50-52 AVON STREET

Memorandum from Department of Building Inspection, Portland, Maine

AP 50 Avon Street-I

Subject: Building permit for alterations of
lodging house at 50 Avon Street

FLOOR PLAN

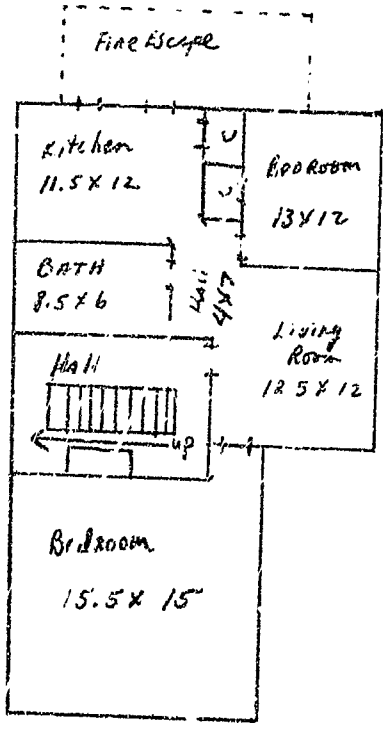
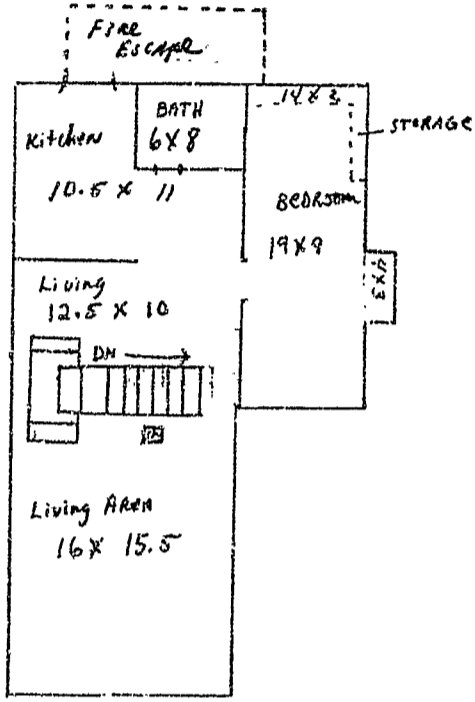
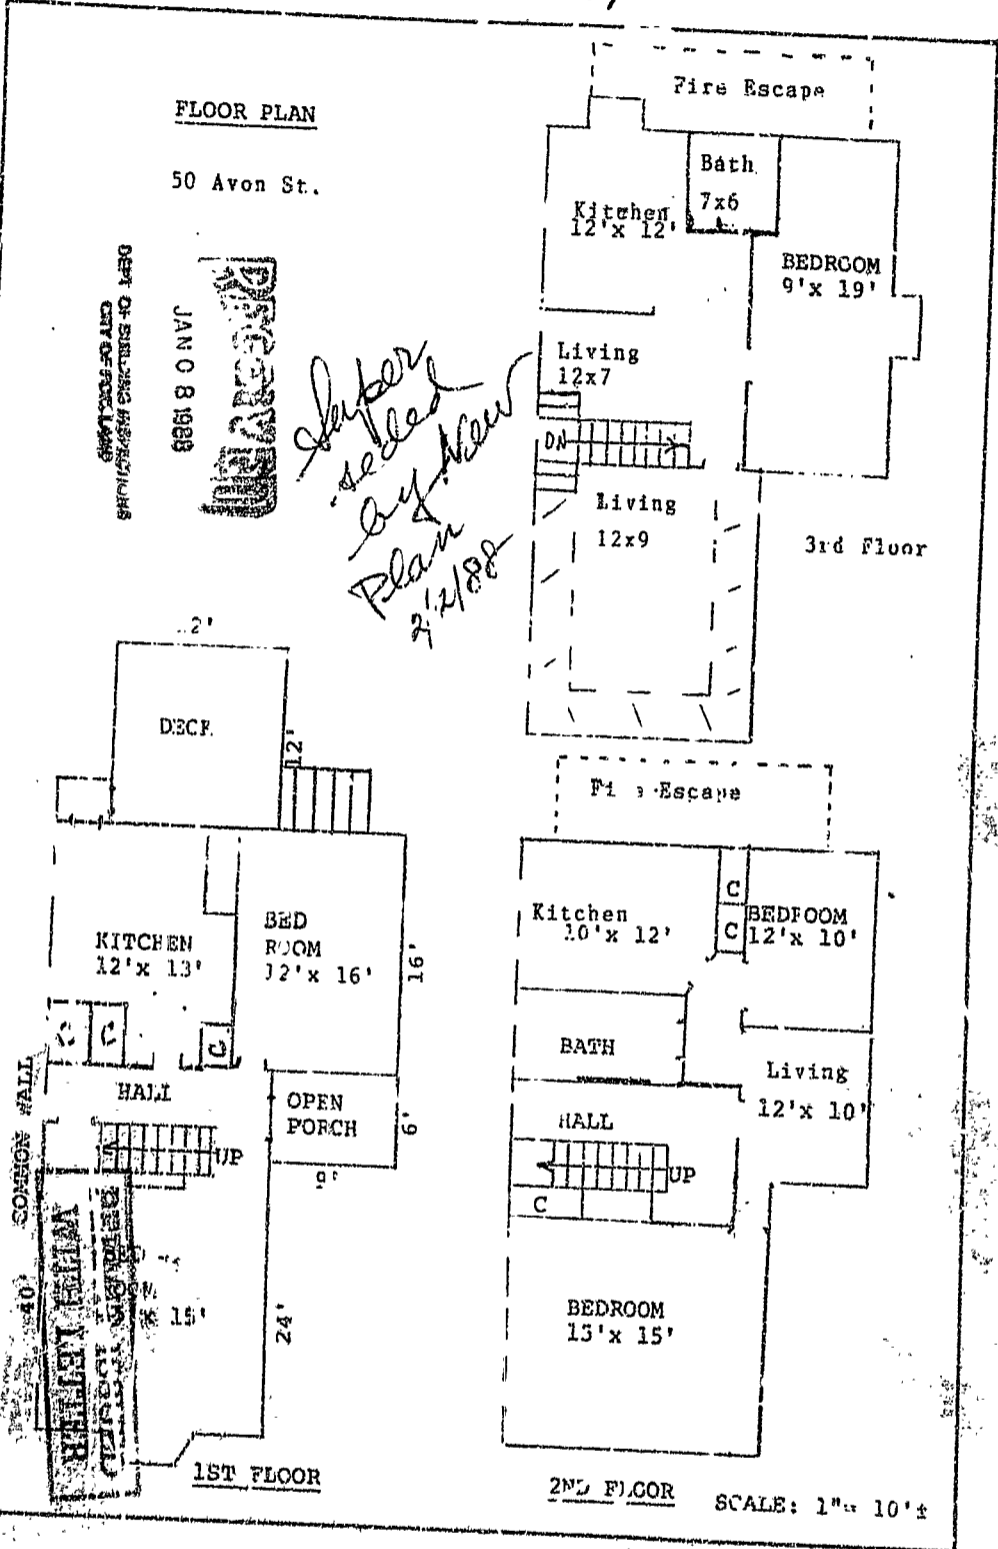
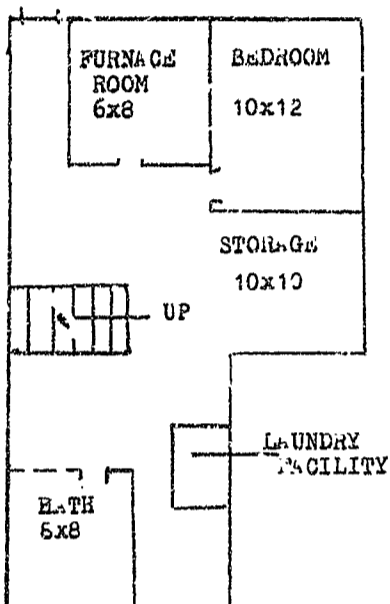
Please review your floor plans and consider whether your proposed apartment units meet the R-6 Residence zoning requirements. Then advise this office as to whether or not these new regulations can be met by your proposed floor plans for three apartment units at 50 Avon Street.
